**PROJECT** 2025-010948-HDRB, 800 Gildersleeve St., Don Gaspar Area Historic District, Contributing,  
**DESC:** Jennifer Salimbene, agent for Shane Woods and Gabe Rippel, owners, request approval for the removal of historic material on a primary façade of a contributing structure. Exceptions are requested to 14-5.2(D)(1)(a) removal of historic material and 14-5.2(D)(5)(a)(i) historic windows shall be repaired or restored wherever possible.

**CASE NUMBER:** 2025-010948--HDRB

Project description: Andrew Lyons, agent for Roxanne and Brian Morgan, owners, requests primary façade determination for a contributing primary residential structure and historic status review of a non-statused accessory structure.

CASE # H-15-073A

① EXISTING EAST ELEVATION

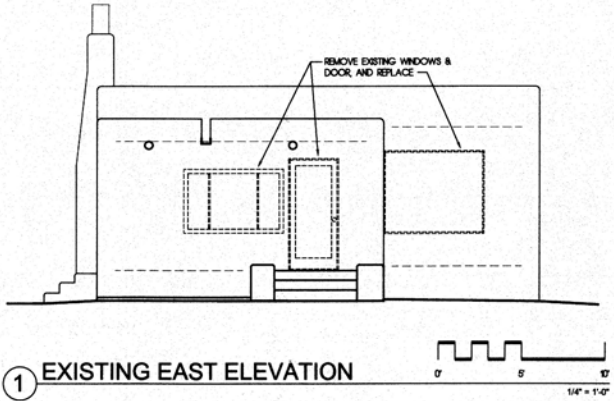
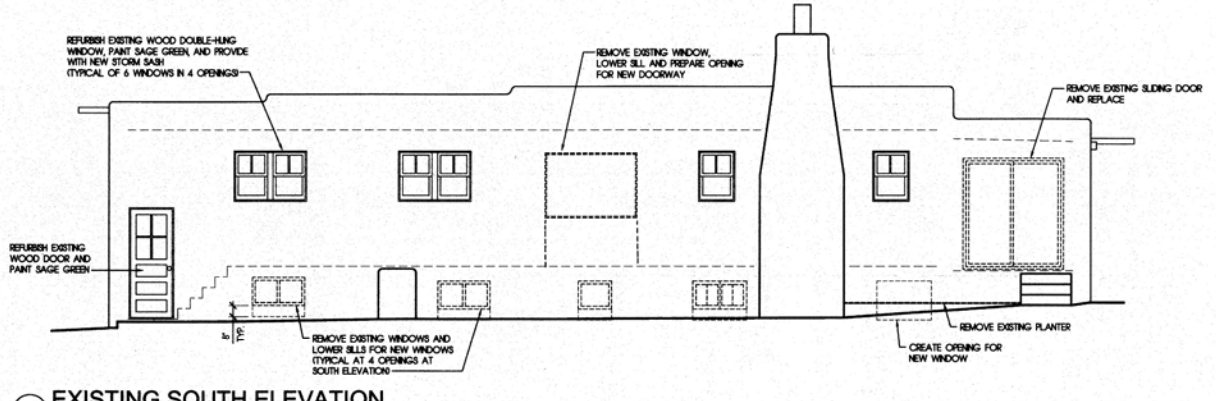
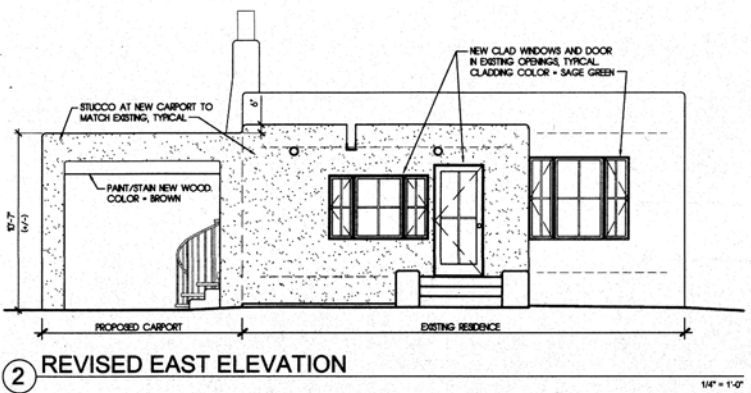
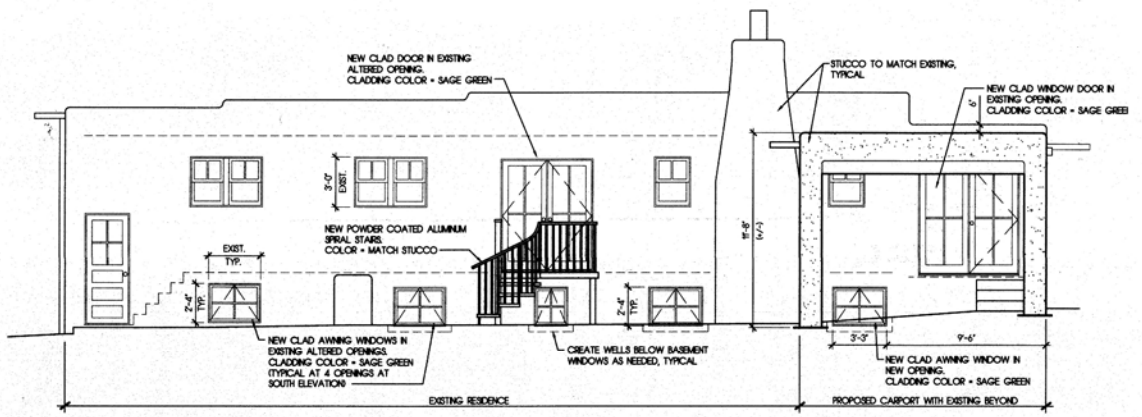
Member Boniface noted the south part of the portal was infilled with a non-historic sliding patio door. It also appeared there was something similar to that going on the north side of that same portal. He asked if Staff was suggesting the north side of that portal would not be primary.

Mr. Rasch said that was a good question. He did not suggested the north elevation of the portal should be primary. It does have that massing interest but he didn't see anything on the north being different from the east or the west. And on any of the portal, if the Board does make the east, north or south parts of the

Member Boniface said it would include the existing opening size and width, so the applicant would need to honor the opening size. He asked if Mr. Lyons understood that.

Member Boniface said the opening that the patio door is in, would have to remain (at its present dimensions). It could not change in size but the applicant could infill the opening with something more historically in keeping with the rest of the house. But it would have to come back to the Board for approval. If a motion was made to have that south side designated as primary and later they decided they wanted to upgrade those patio doors, they could not infill that opening.

**Member Boniface moved in Case #H-15-073A at 800 Gildersleeve Street, to retain contributing status and approved per staff's recommendation, to designate the east and south façades, elevations 1, 2, 3 and 6 as primary and to assign contributing historic status to the converted garage with the east elevation, #1, designated as primary and indicating that the Applicant has recognized non-historic windows and doors in some openings he might later request to upgrade. Member Roybal seconded the motion.**

Mr. Rasch said the entire façade facing east and facing south is recommended.

1 EXISTING EAST ELEVATION  
1/4" = 1'-0"

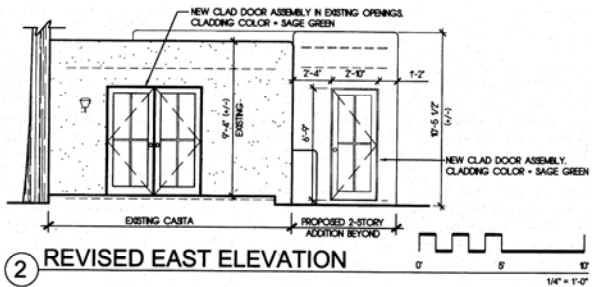
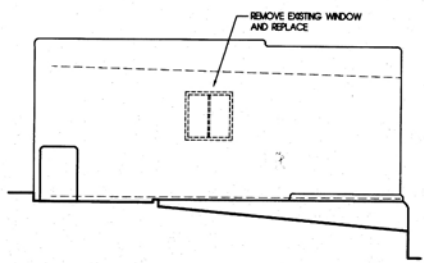
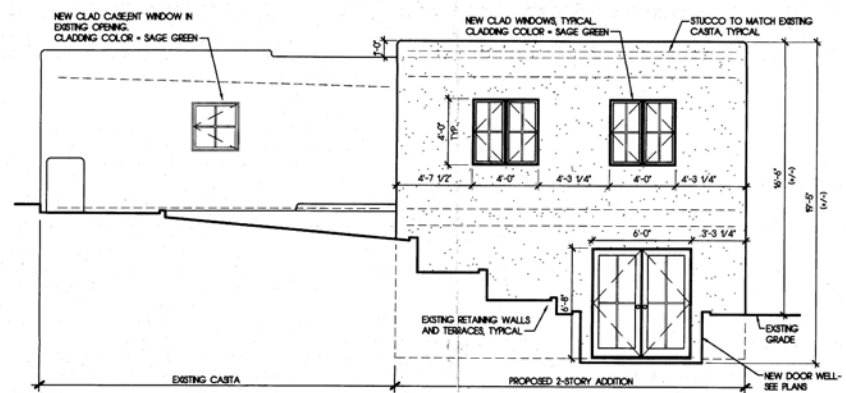
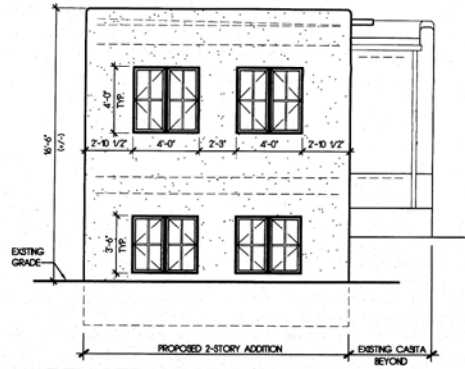
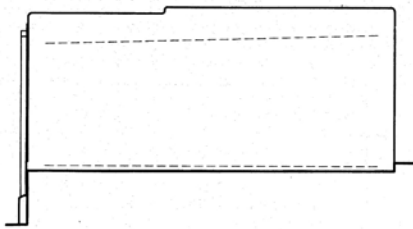
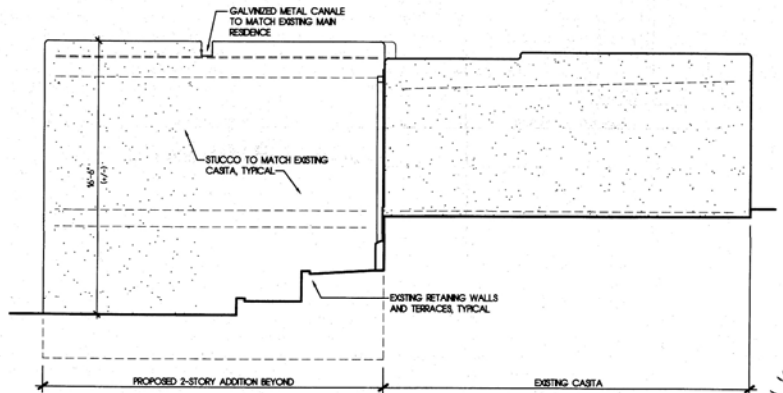
Member Boniface said in reviewing the elevation drawings of the Casita, it appears that the lower floor is probably buried about three feet at least on three sides and even steps up on the north and south sides as well. So the only spot where there is actually 19'+ wall is just right where the French doors at the entry on the ground floor on the north elevation and the entire west elevation. It looks like all three sides – the fourth side being contained by the existing casita/garage. He understood the Board still needs to make an exception for that but wanted to clarify that it is the case.

Mr. Rasch said that is correct.

**MORGAN RESIDENCE - CASITA**

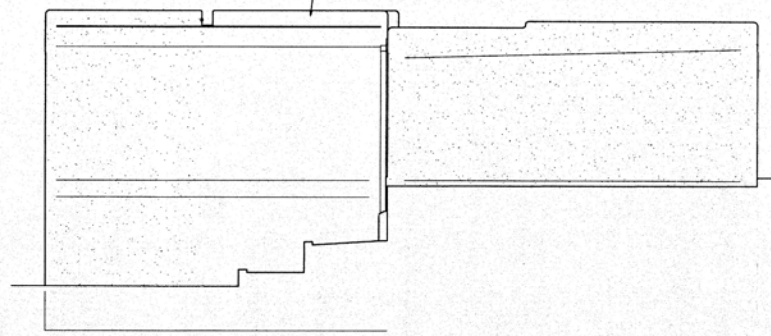
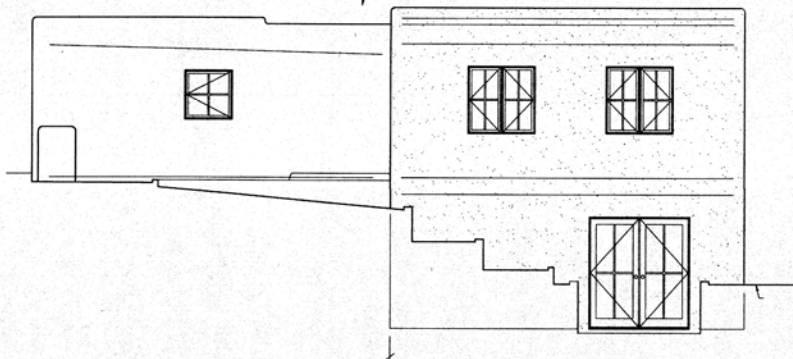
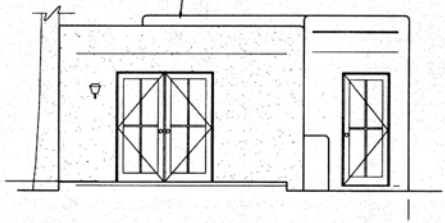
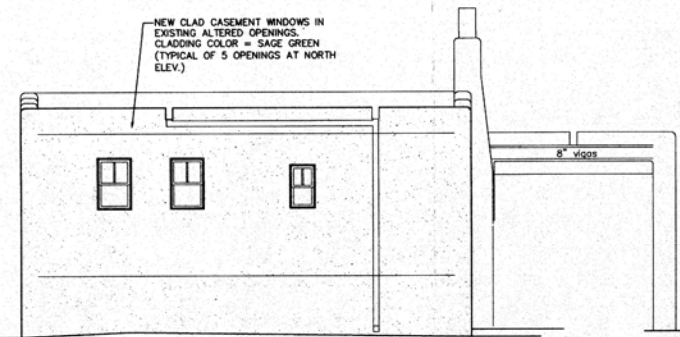
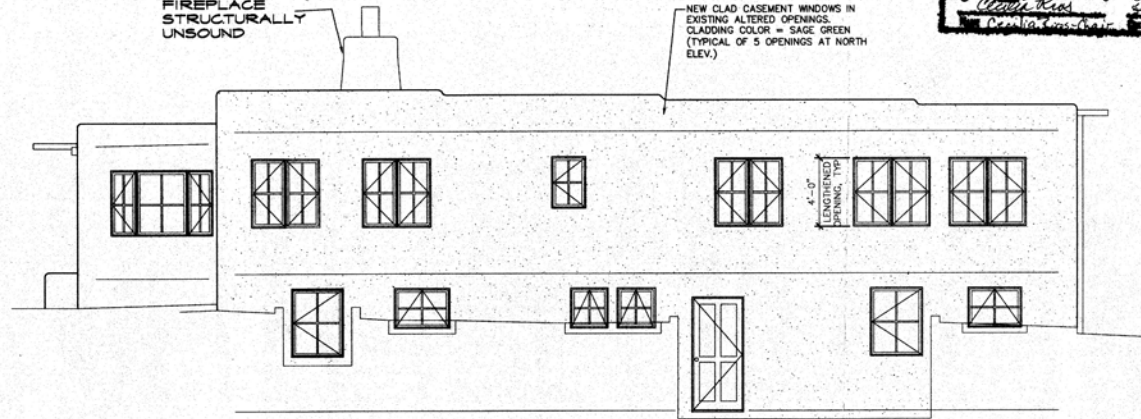
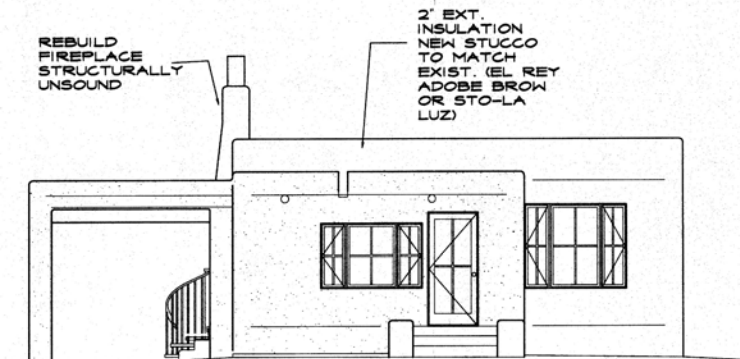
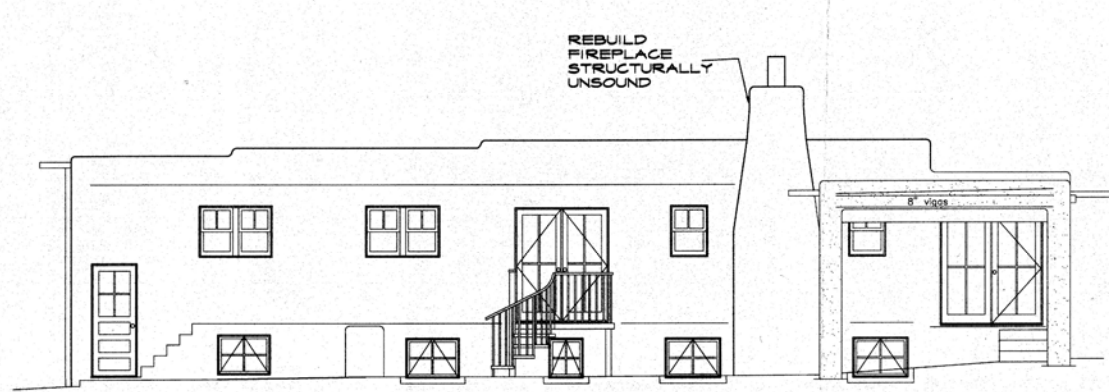
Member Boniface said these drawings are impossible to understand. The drawings are mis-labeled in terms of elevations and the elevations don't match the floor plans. The Board needs to postpone this and ask the applicant to submit accurate drawings.
